ZBA 2022-29

Petition of Bank of America, NA  
342 Washington Street

#### ZBA 2022-29 BANK OF AMERICA, 342 WASHINGTON STREET

Subject: Bank of America Wellesley  
**Construction Change Narrative Letter**  
Project Number: 005.3722.000  
File Code: 5CD

## EXISTING WINDOW REPLACEMENT

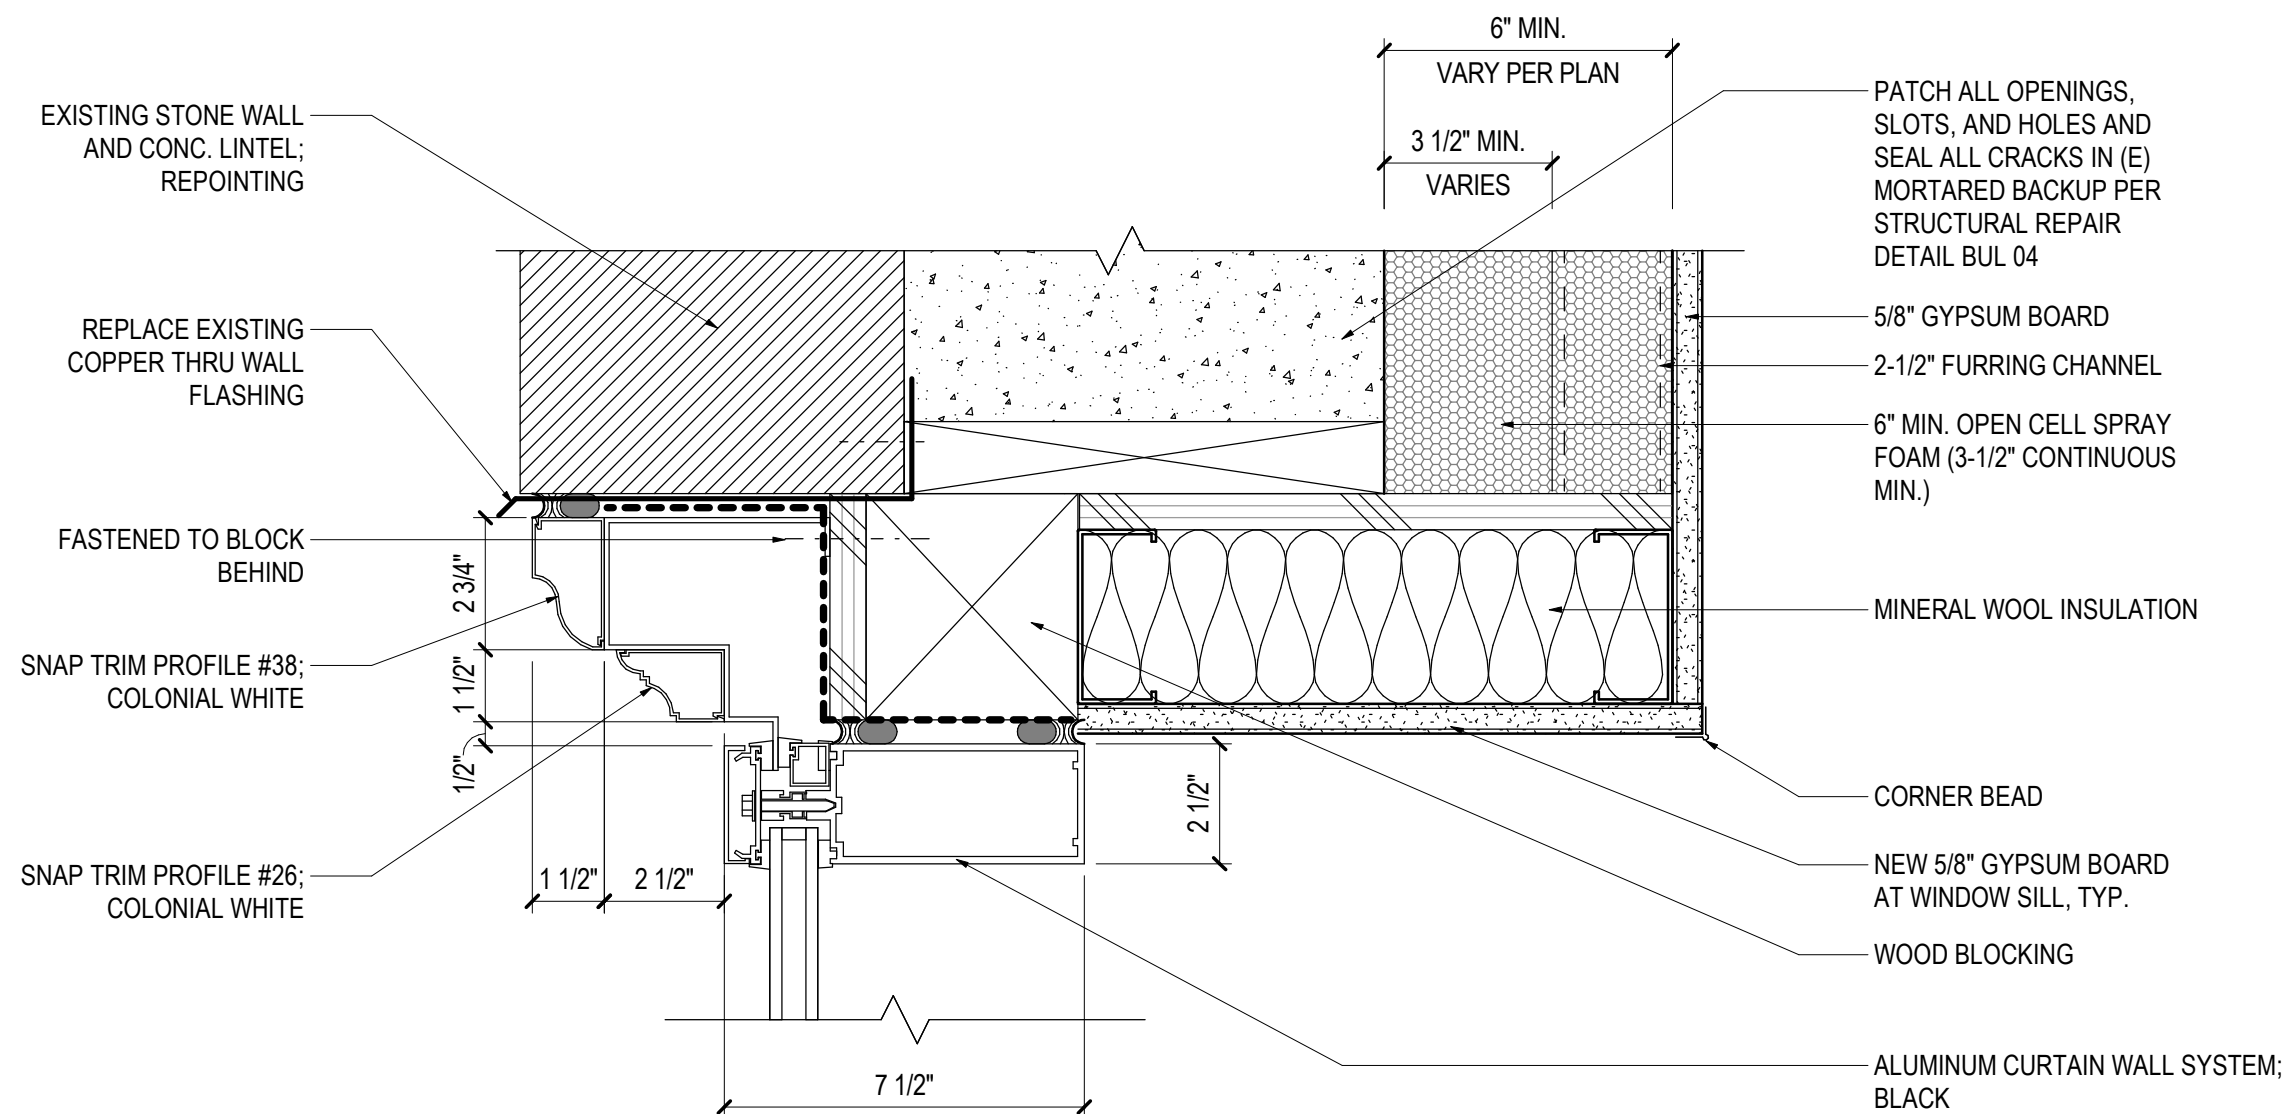
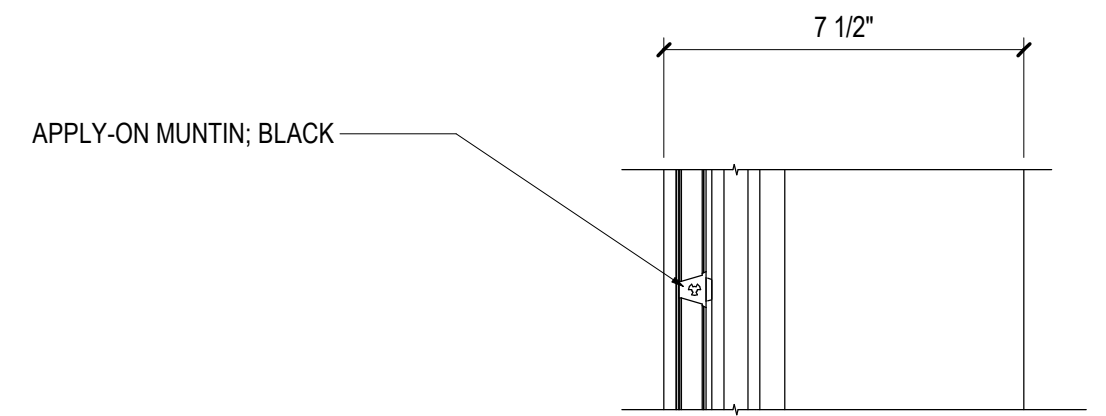
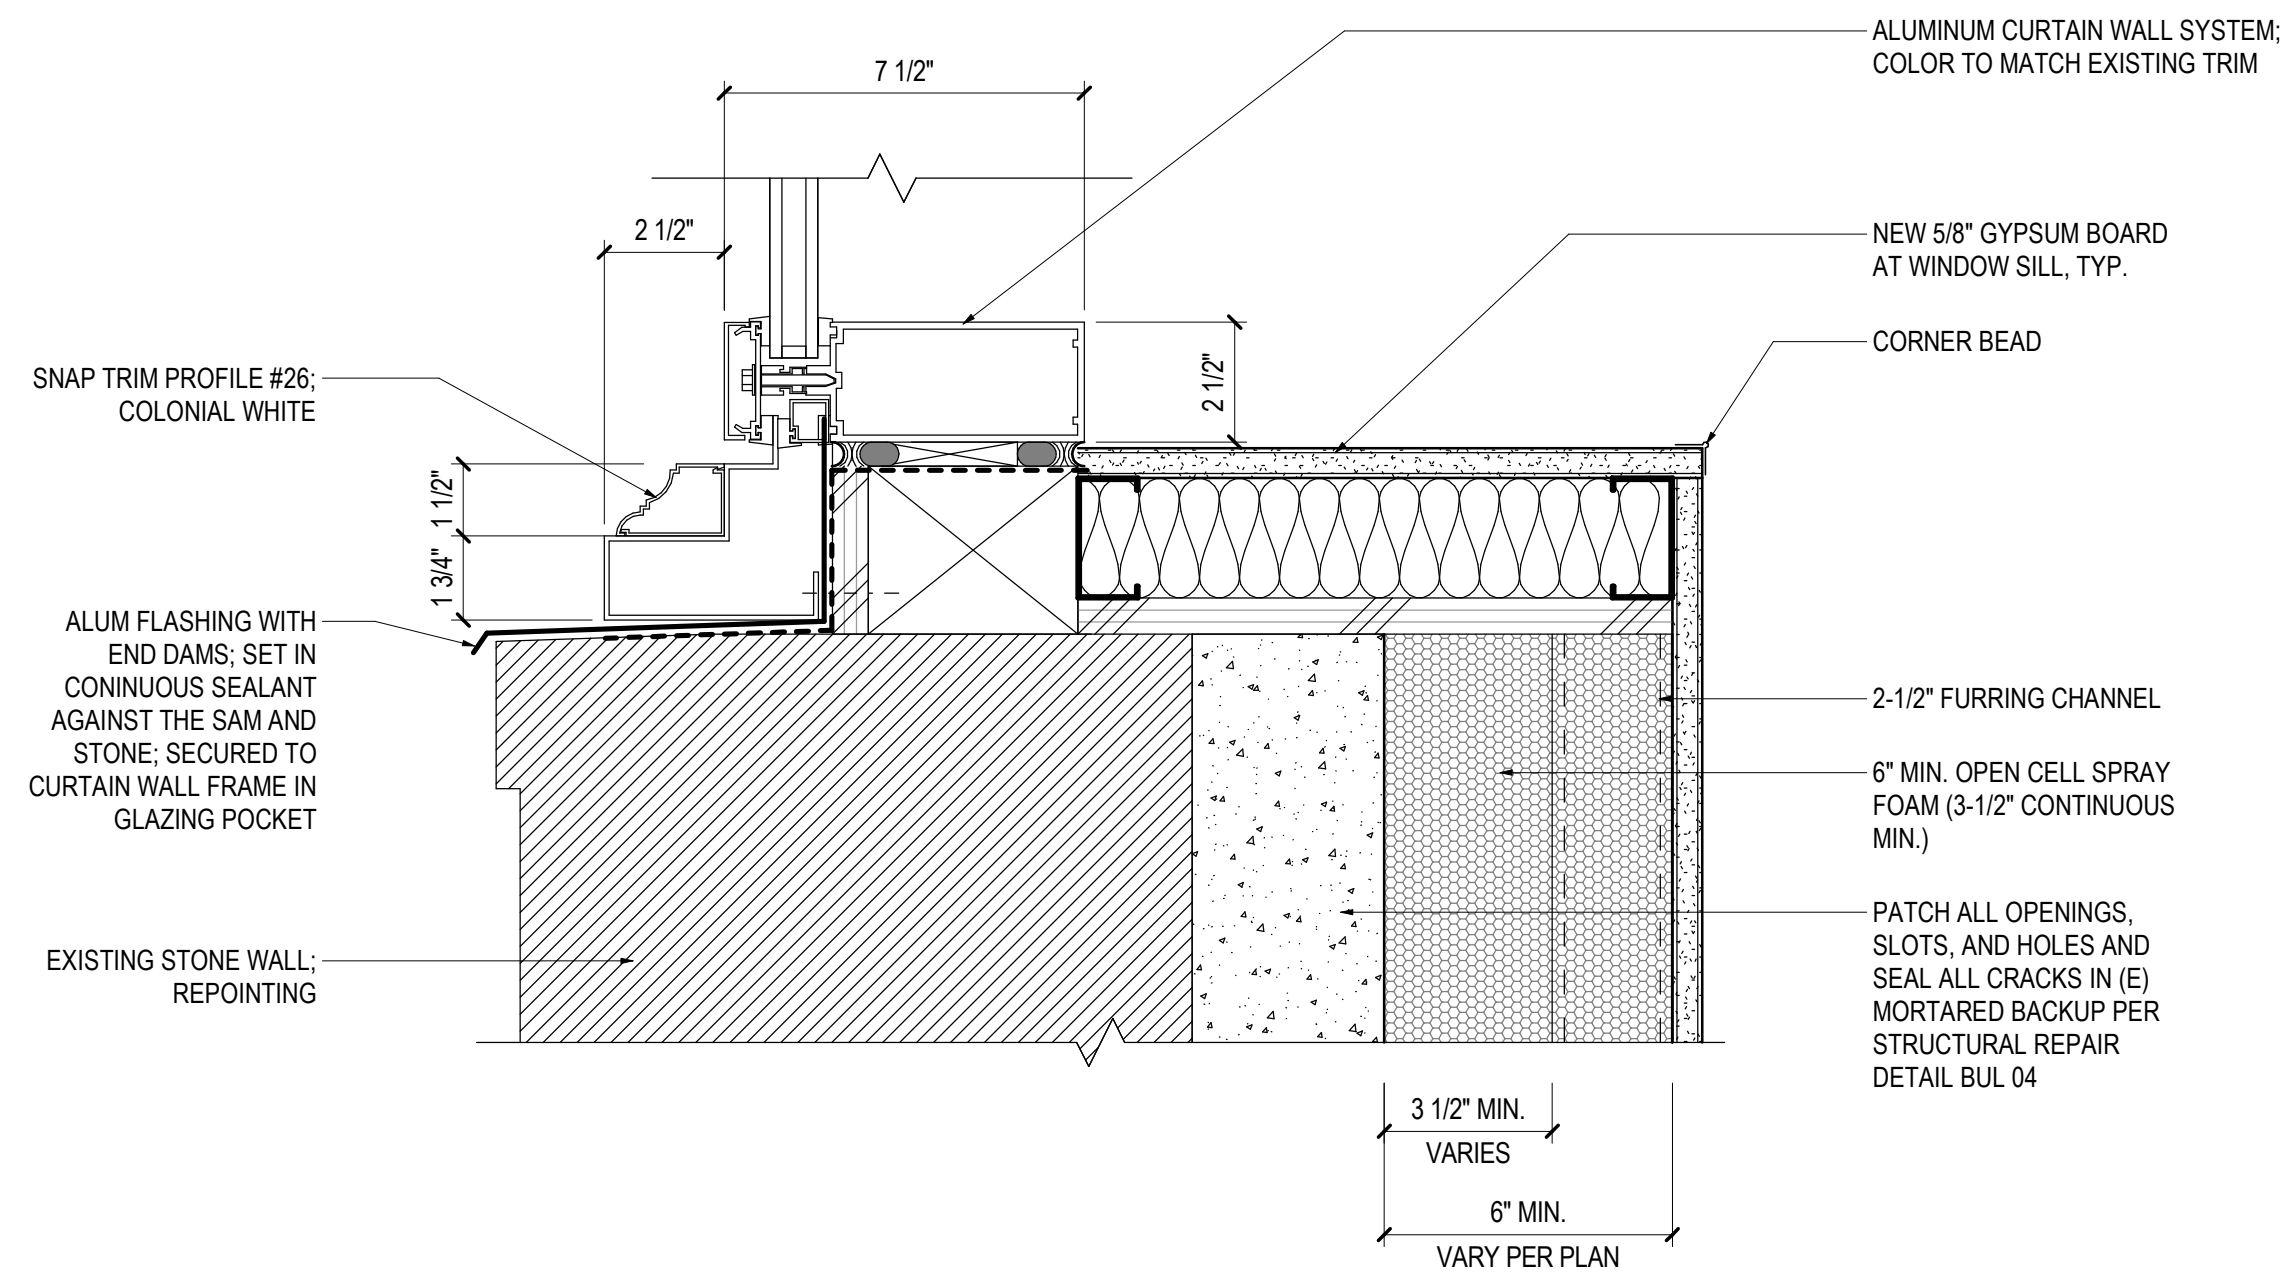
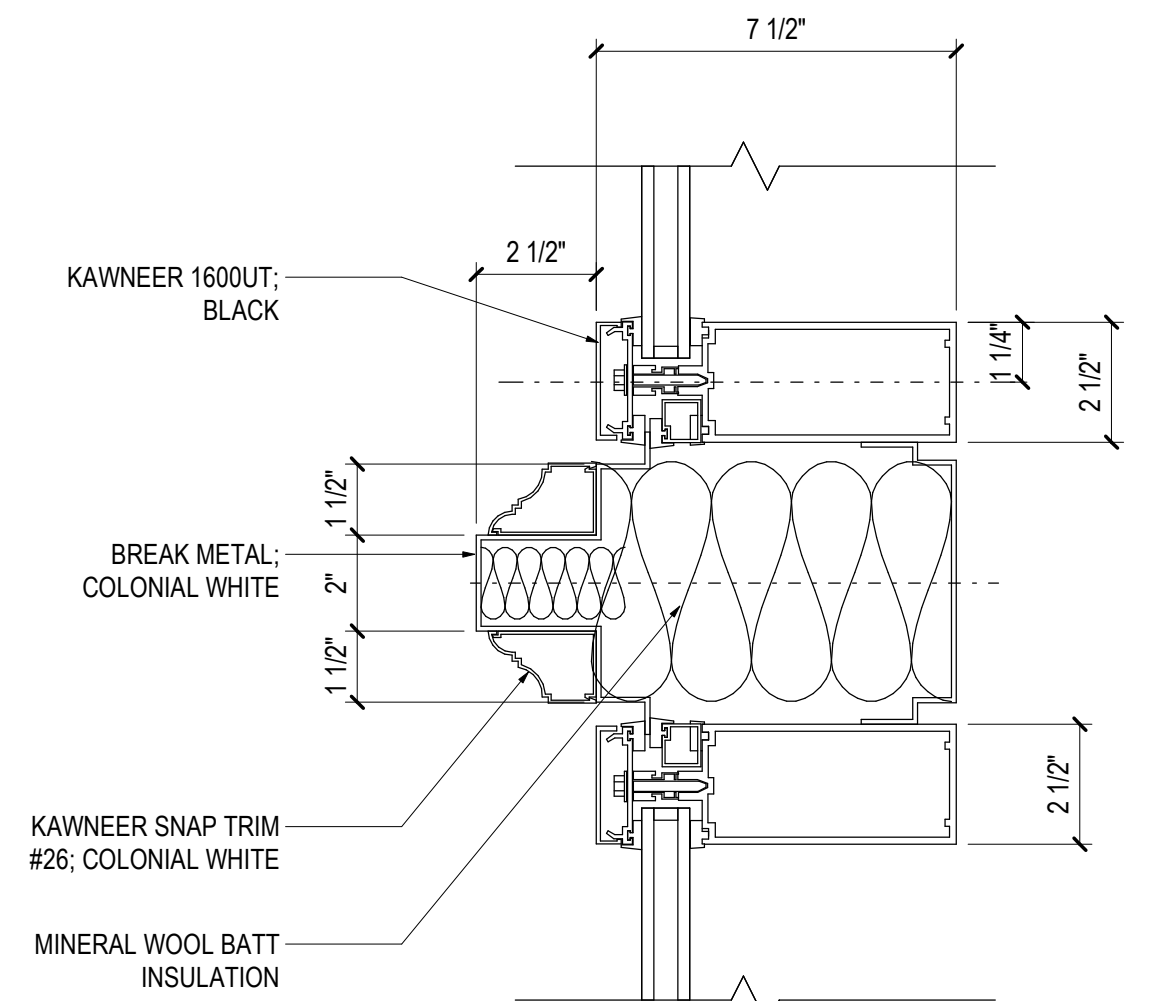
Ms. Reker said that the existing large composite windows suffered a lot of water and insect damage. She said that they will replace them with matching windows with the same detail and color. She said that the existing windows will not survive the construction process. Mr. Adams said that the new windows in the existing building will look like the old ones but will be made of slightly different materials. He said that the new addition behind the existing building facing Washington Street will have windows of a similar size but are more modern looking.

1. **Replace four (4) large existing windows on south and north façade of the building** – these four existing windows are showing evidence of water leaking and insect damage. See Appendix 'A' for existing window conditions. Gensler proposing to replace the window with Kawneer curtain wall system. The curtain wall system can work with snap trim pieces that closely resemble the existing window trim. For further details, please refer to page AR-09 in the presentation deck.
